## TECHNICAL BULLETIN

**Document:** TB\_T318\_016\_DIFF\_BELLEVILLE

**Subject:** Belleville for differential preload setup

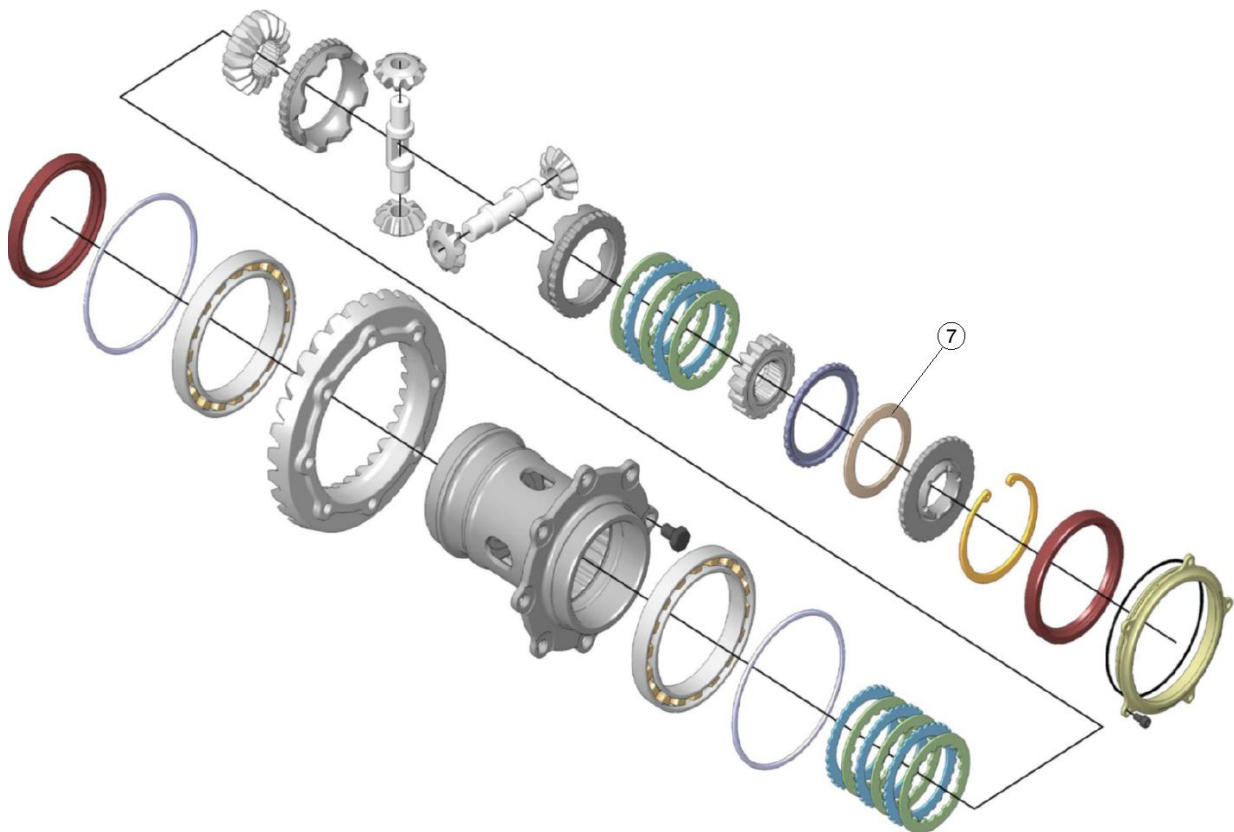
A list of allowed alternatives for the differential Belleville washer is authorized.

For the item 7 in the picture above it is allowed the alternative use of the parts listed below

Part number	Description
F1910313	Belleville 0.8 mm
F1910314	Belleville 1.0 mm
F9046326	Belleville 1.2 mm
